JO/P6638
24th March 2017

2-8 Bloomsbury Street and 52-56 New Oxford Street, Bloomsbury Plaza, London, W1
Section 73 Application to vary Condition 3 of Planning Permission 2015/3749/P
Planning Portal Ref: PP-05941753

On behalf of our client, Blenheim House Construction Limited, we write in support of an application to vary Condition 3 of planning permission 2015/3749/P at 2-8 Bloomsbury Street and 52-56 New Oxford Street (Bloomsbury Plaza).

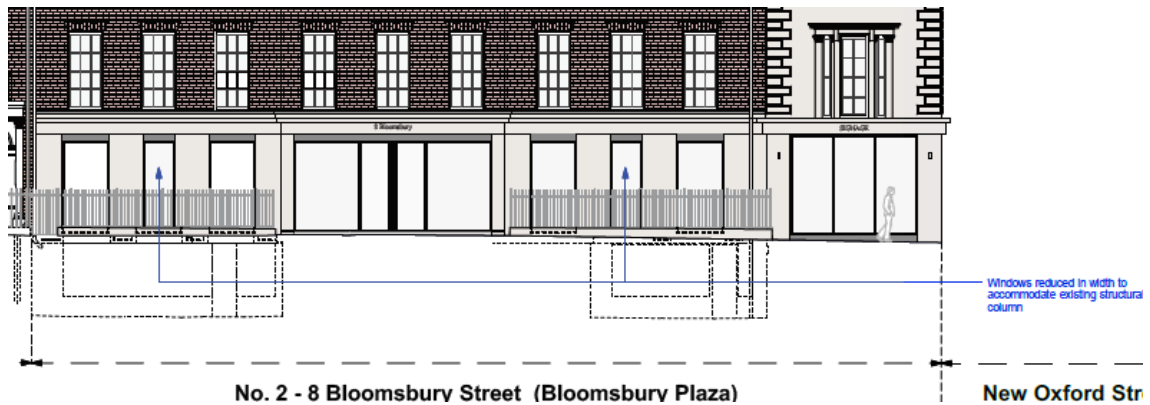
The small boiler flues and mushroom cowl proposed on top of the plant room were mistakenly left off the original proposed drawings; however they simply replace the existing ones which were in situ as shown in the site photos below.

The proposed louvered grille to the front of the existing plant room will be constructed in aluminium and will be painted to match the surrounding rendered façade. Whilst not shown on the existing drawings this will replace an existing door which is shown in the photo below.

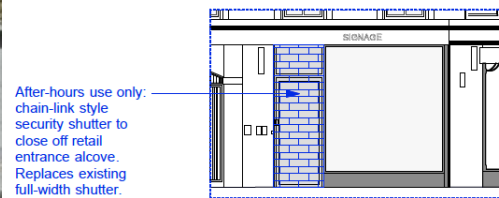
It is also proposed to install a brick bond roller shutter across only the recessed entrance door to the existing retail unit at 56 New Oxford Street. Whilst not shown in the existing or proposed drawings in the 2015 permission, the shop does currently have a full width roller shutter (shown in the photo below). The removal of this and its replacement with a much smaller version (required to prevent anti-social behaviour in the deep recessed entrance) represents a significant improvement over the existing.
